Rezoning Transportation Analysis

Petition Number: 2021-163

Date	Description
08-26-21	First Review (LH)
09-23-21	Second Review (BKB)

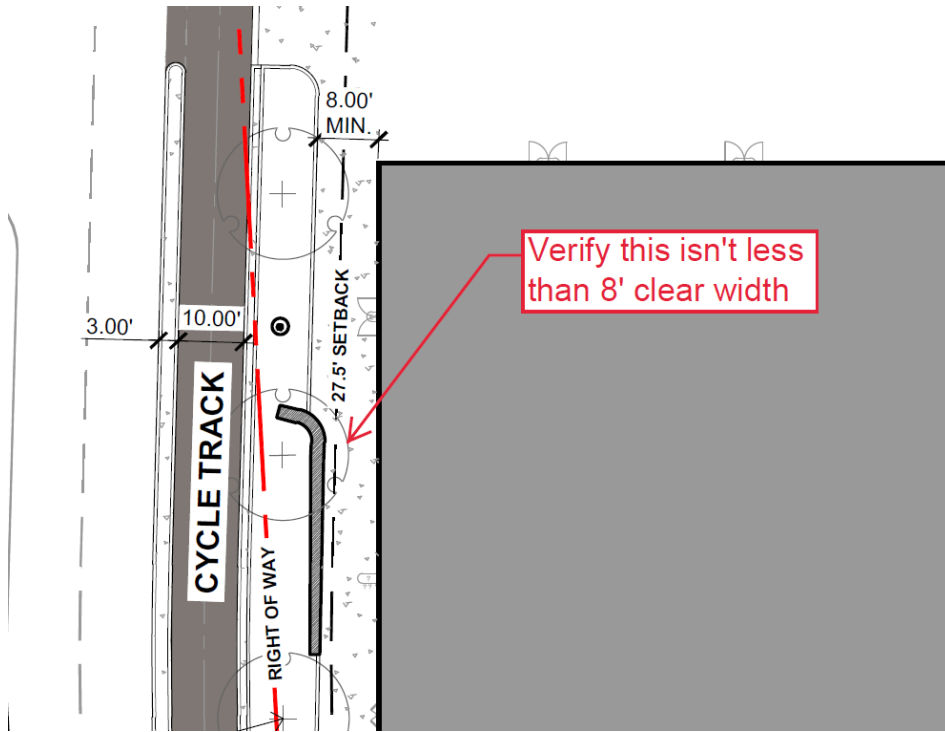
4. **6th Street Cross-Section:**
 - a. ~~**New Cross-Section:** Include a second cross-section that shows a consistent 10' cycle track width and 11' travel lanes.~~
 - b. ~~**Right of Way:** Show right of way line on cross-section and ensure building face is outside of right of way.~~
 - c. **Pedestrian Pathway:** Update site plan and conditional notes to show minimum 12-foot sidewalk width. **Updated per Site Plan Dated 09-13-2021:** 8-foot minimum sidewalk consistent with all other streetscape improvements in area. Verify that 8-foot sidewalk is achieved as it appears to be less than that in an area below the dimension on the site plan:

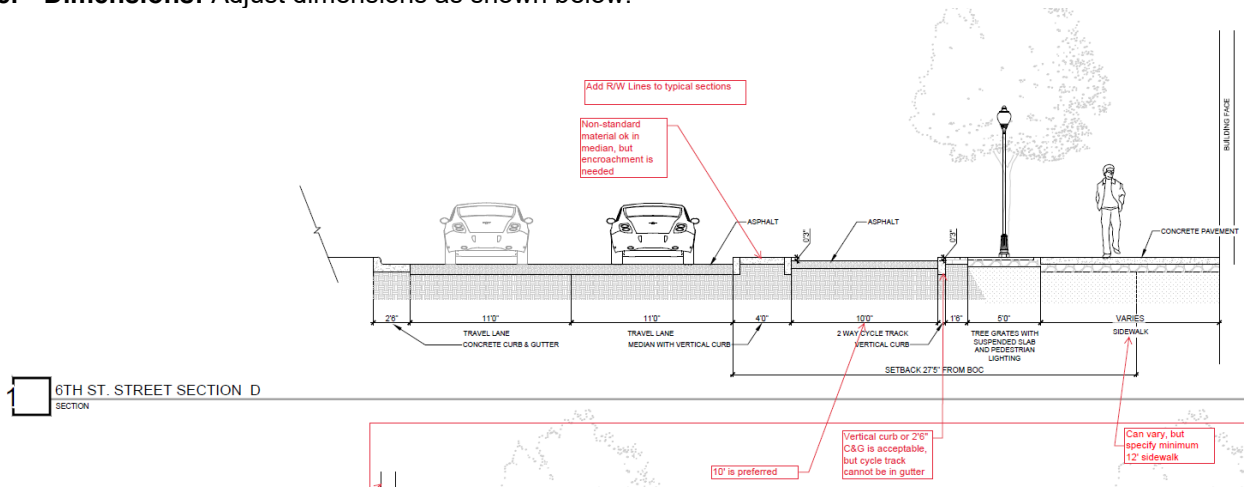
d. **Cycle Track:** Update site plan and conditional notes to show the correct and varied dimensions, as shown below. Add a conditional note that vertical curb and curb and gutter are both acceptable adjacent to the cycle track, but the gutter width cannot be used to account for the 10' cycle track width. Add a conditional note that nonstandard material is allowed in median between cycle track and vehicle travel lanes, but an encroachment permit will be required. Additionally, provide a conditional note that specifies the commitment of constructing the cycle track on 6th Street.

5. 7th Street Cross-Section:

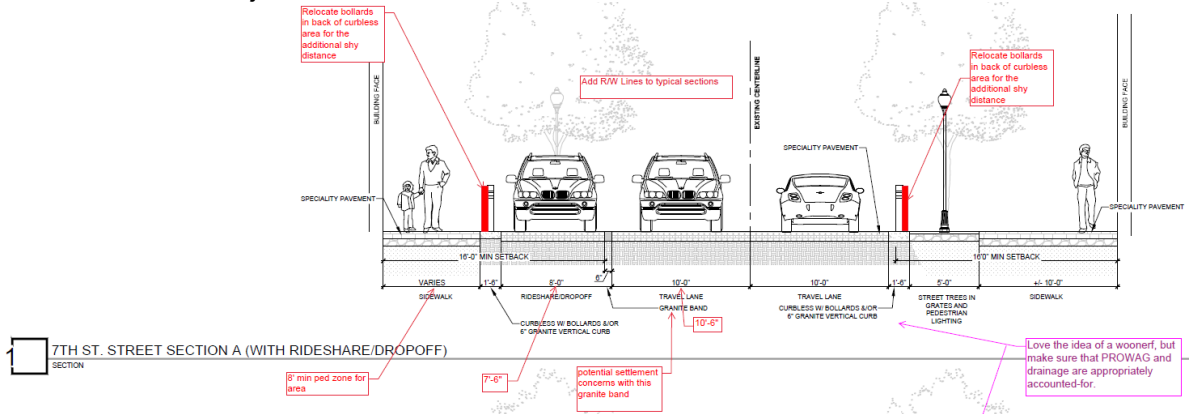
e. **Dimensions:** Adjust dimensions as shown below:

a. **Travel Lanes:** 10-foot travel lanes are not suitable for shuttles that would frequent the hotel or a GATS bus if 7th Street was used as a detour. Update travel lane adjacent to hotel to 10 foot, 6 inches minimum width. If using vertical curb, adjust for 11-foot travel lanes.
